ITEM FOR ENVIRONMENTAL COMMISSION AGENDA

NAME & NUMBER OF PROJECT: Rainey Tower
SPC-2021-0129C

MEMORANDUM

CASE FOLDER: SPC-2021-0129C

Exhibit 5: Sonic Tomography reading

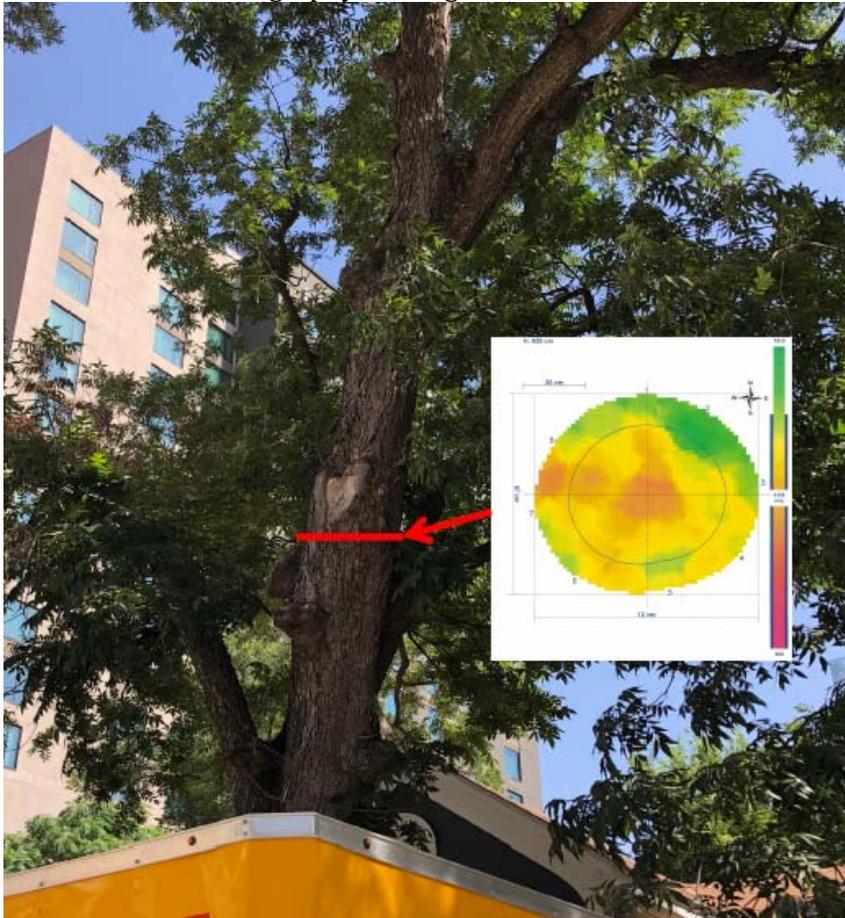
This scan shows less sound wood in the center and extending outwards through the shell wall between sensors 3-8, and between 8-1. This scan was taken below an old, exposed pruning wound, and above branch nubs. Failure of this portion of the tree would result in the loss of a significant part of the tree canopy (Image 2). Eight sensors were used in this scan. The scan at this level is structurally compromised.
